# **Matanuska-Susitna Borough LiDAR & Imagery Project Quality Assurance Report Point Mackenzie Block (V2)**

**Written by Rick Guritz**

**Alaska Satellite Facility**

**February 11, 2013**

Figure 55, Fill values around good data inconsistent (Left), corrected (Right).

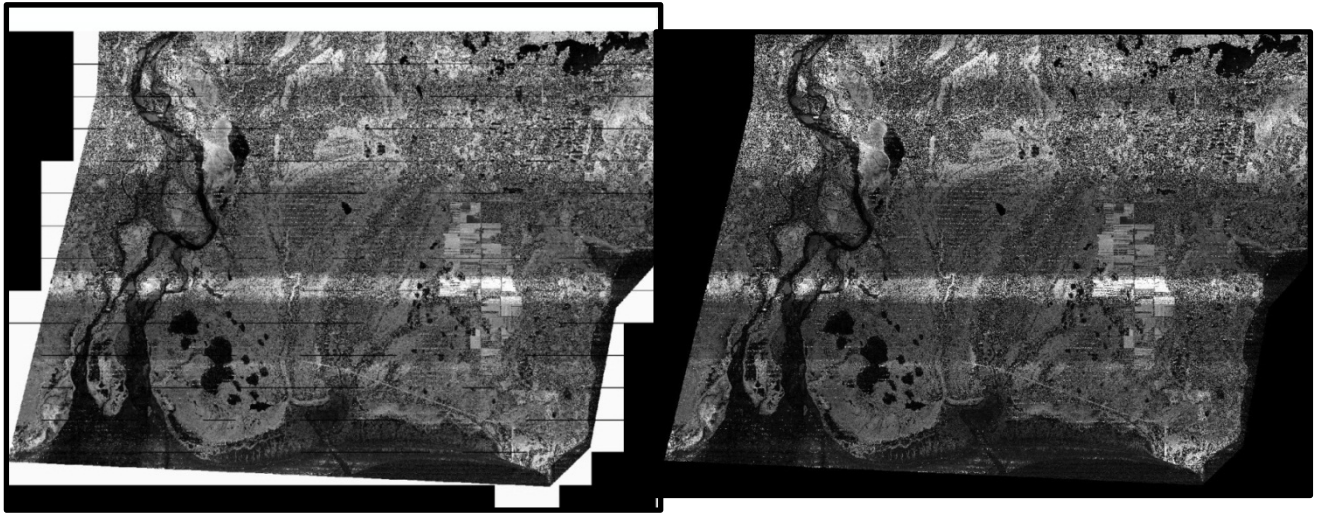
**LiDAR intensity boarder not set to NoData** - On 12/16/2011, UAF reported that fill values outside the block boundary were set to 249 or white and 0 or black (See Figure 55). UAF requested that these should be set to NoData to be similar to the bare-Earth and First-Return gridded products.

Figure 56, Bare-Earth DEM needs trimming (Left), corrected (Right).

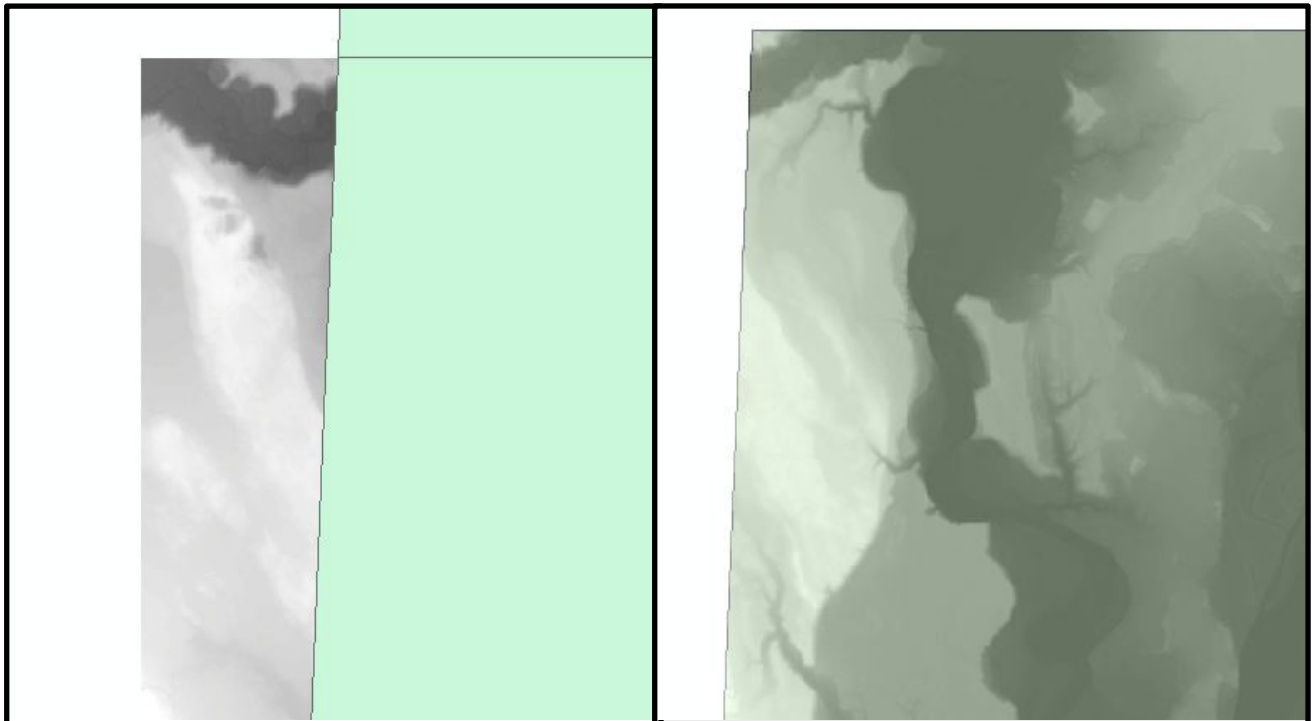
**Bare-Earth DEM needs to be trimmed to block boundary** – On 12/20/2011, UAF reported bare-Earth tile PM\_063 needs to be trimmed to the block boundary (see Figure 56). With data extending beyond

the block boundary, it made for large differences to be detected when subtracting the bare-Earth DEM from the first-return DSM. UAF encouraged Aerometric to produce and deliver a block boundary layer with its tile grids in future deliveries.

Figure 57, Topology Errors in Contours (PM022).

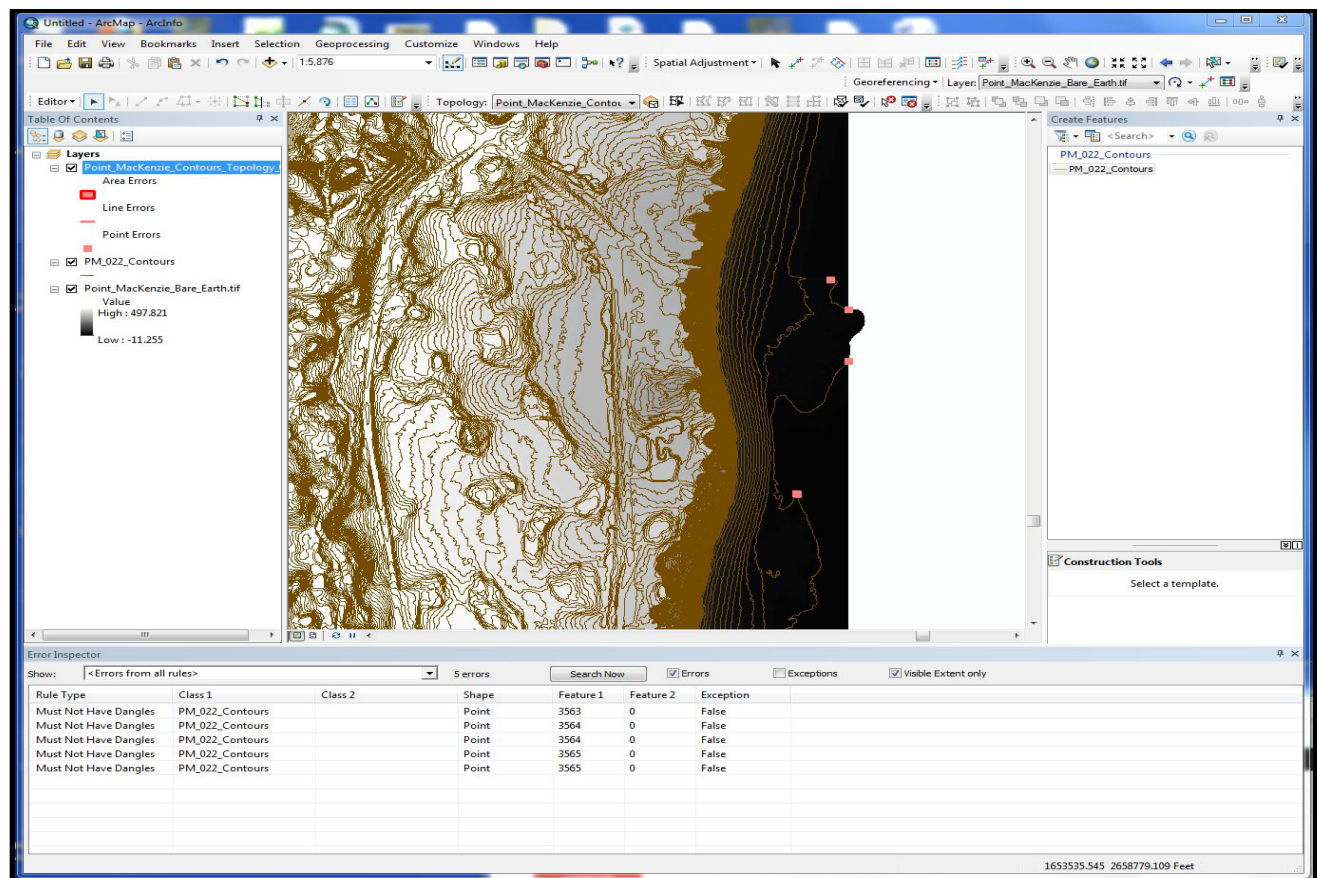
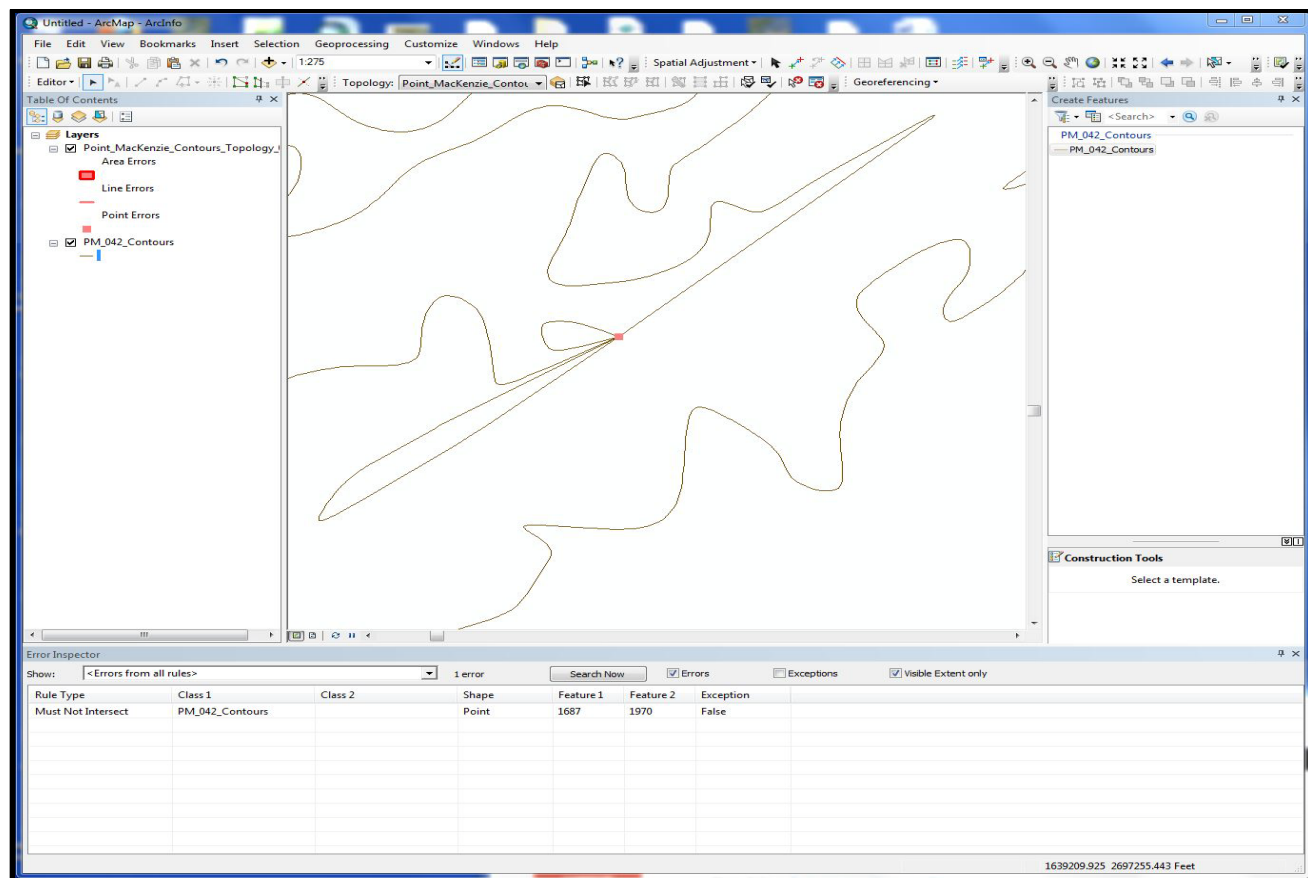
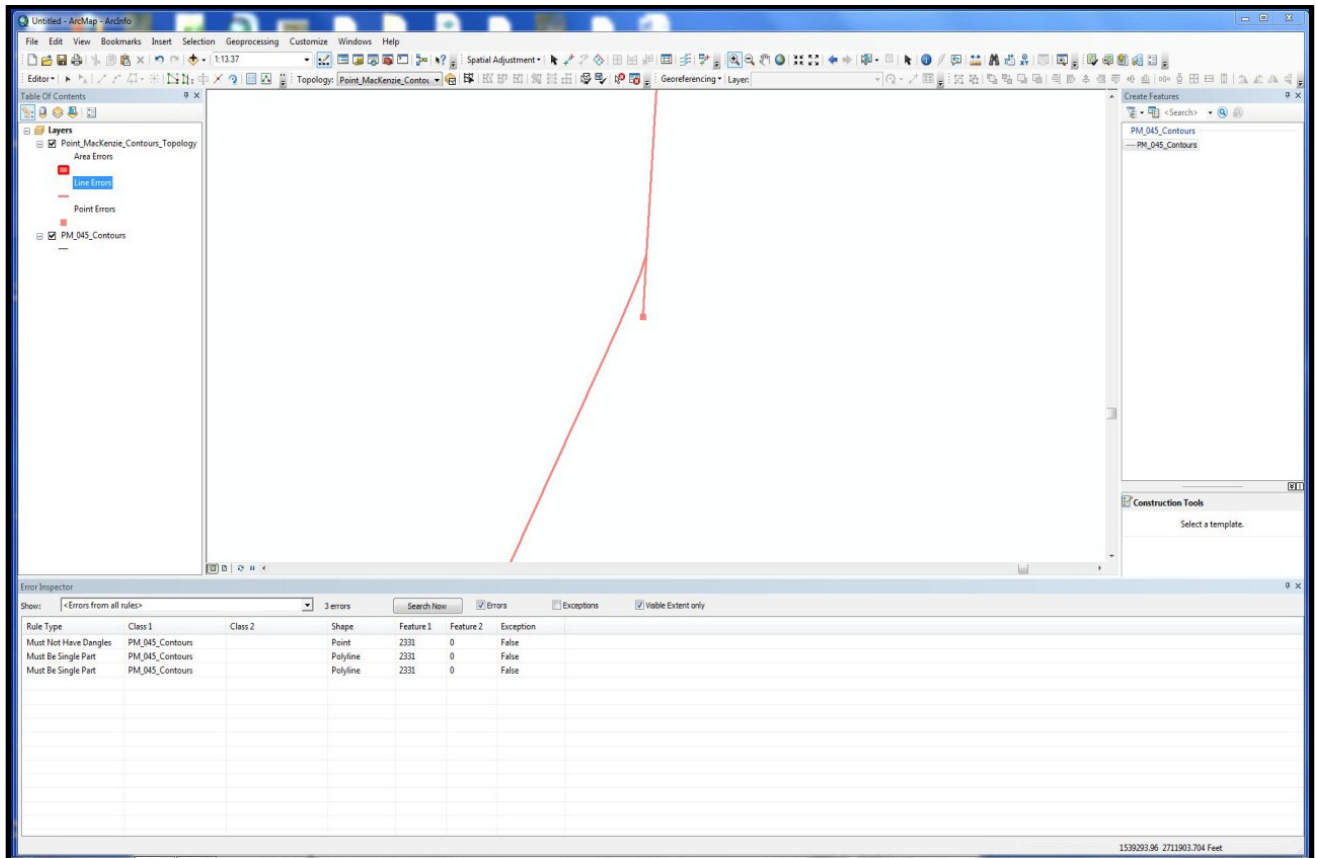
**Contour topology errors** – On 12/28/2011, UAF reported three tiles (PM022, PM042, and PM045) with contour topology errors (See Figure 57-59). This was determined after testing four tiles that contained the largest slopes and topology rules that were supplied by the Matanuska-Susitna Borough staff including: must not overlap, must not intersect, must not have dangles (except at tile edges), and must be single part.

Figure 60, Low vegetation (PM043) Left, corrected Right.

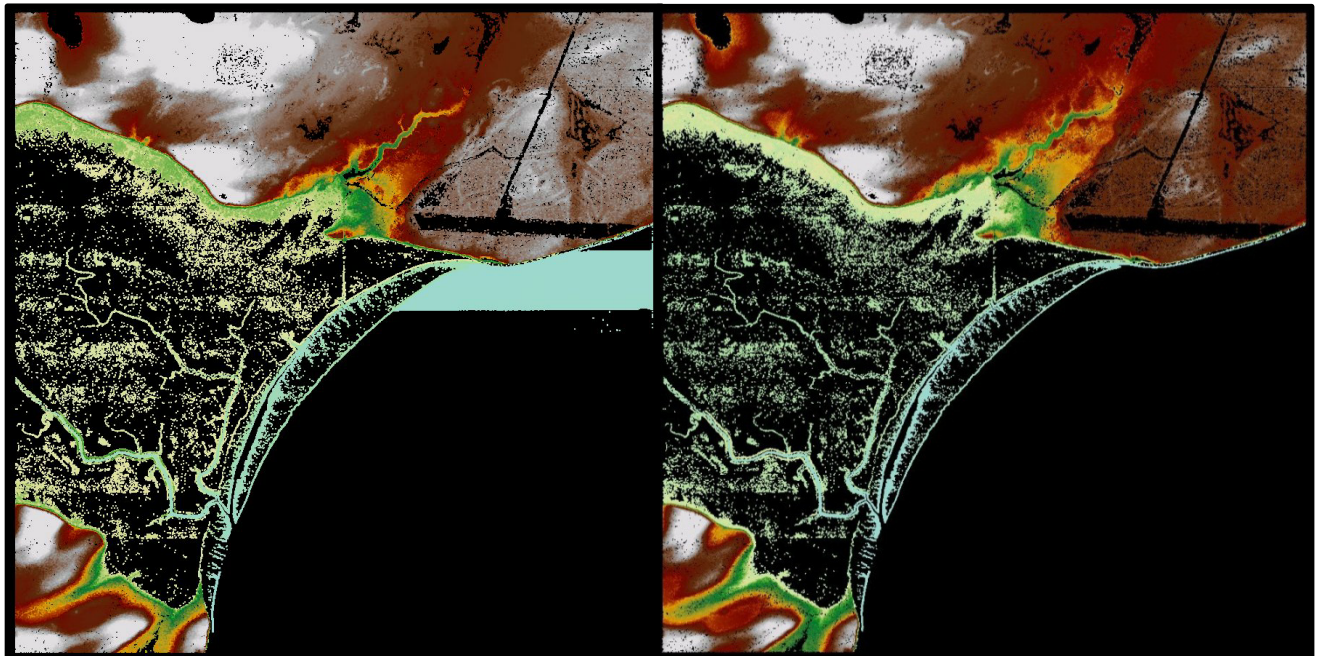
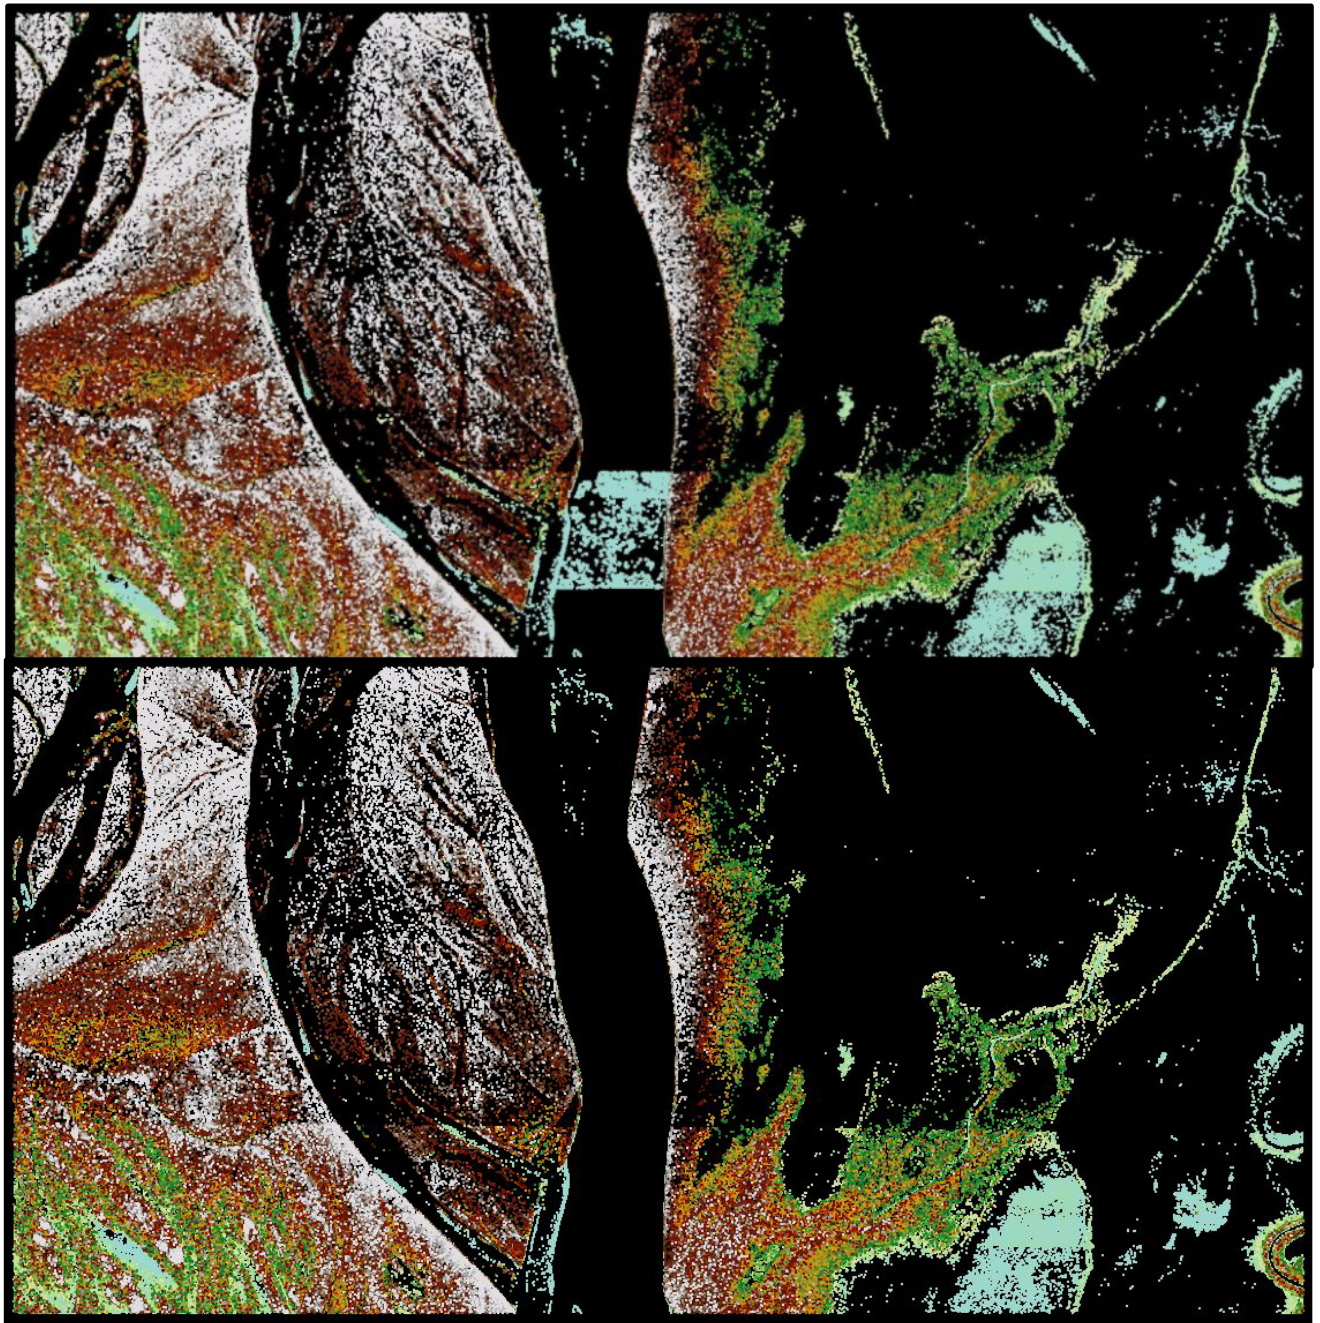
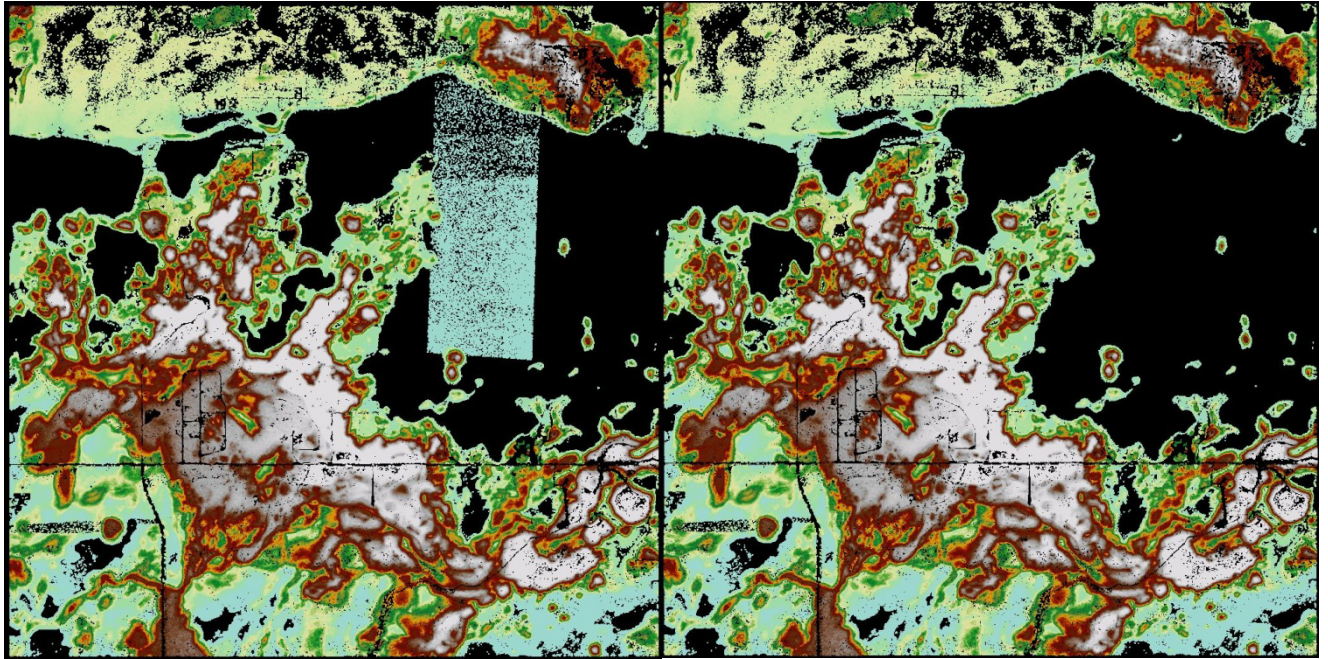
**Low Vegetation errors** – On 03/28/2012, UAF reported additional low vegetation errors that should be fixed (See Figure 60- 62). These include: the northern extent of Cook Inlet still has low vegetation over water (PM043), a block section of the Susitna River water classified as low vegetation (PM046NE and PM047NW), and a section of Big Lake that is classified as low vegetation (PM070).

**Delivery 6** – Aerometric delivered to UAF by FTP on 03/29/2012 fixes to the requested tiles of new LAS point cloud data to fix the low vegetation errors that were reported. **This final delivery of data completed the final corrections that were needed for acceptance of the Point Mackenzie block.**

Figure 63, Lake Height Error (PM068) Left, corrected Right.

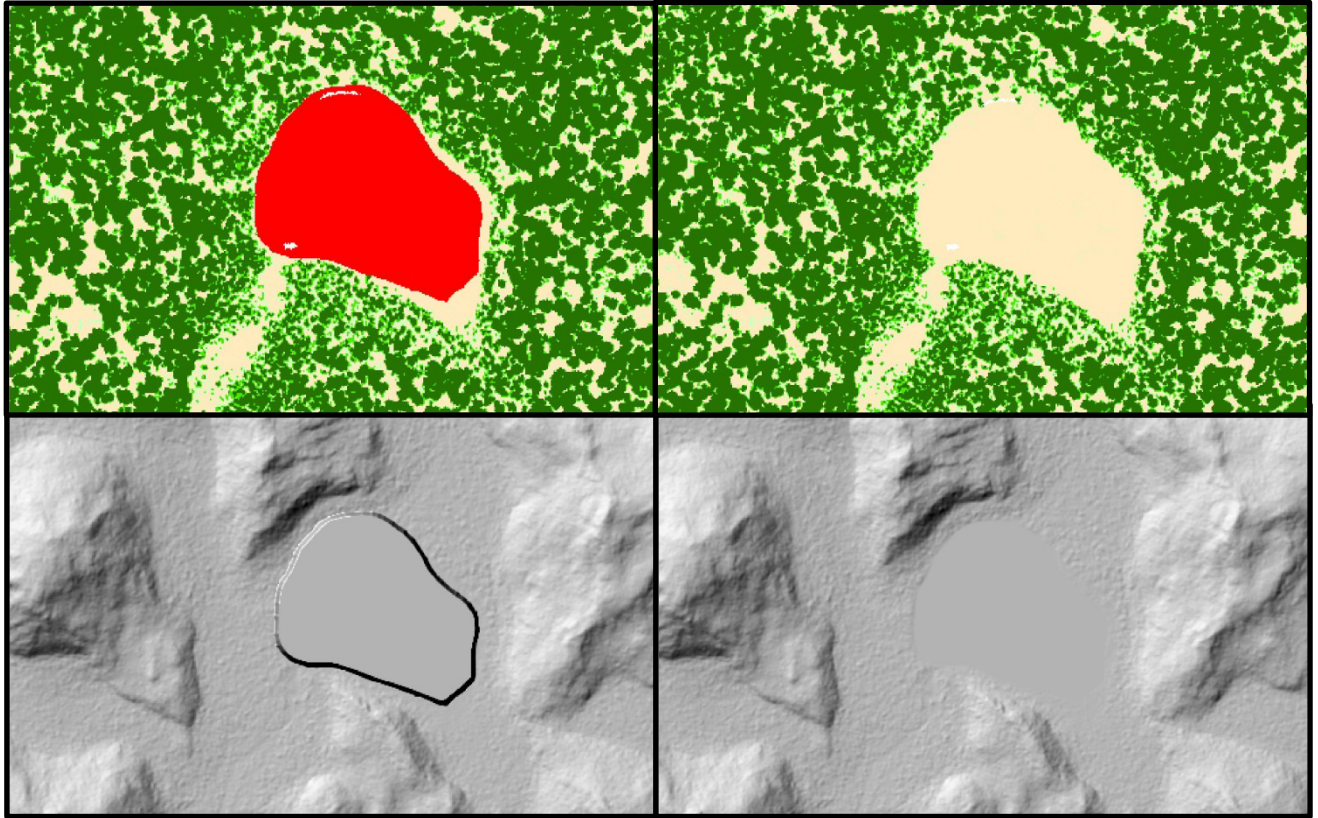
**Lake Height Error** – On 2/11/2013, UAF reported a bad lake height that differed between first return DSM and bare earth DEM by -97 feet (PM\_068\_DEM). This was observed in the canopy height classification as red and also showed up in the shaded bare earth DEM (See Figure 63).

**Delivery 8** – Aerometric staged to their ftp, a corrected bare earth DEM and shaded relief tile for PM\_068\_DEM.
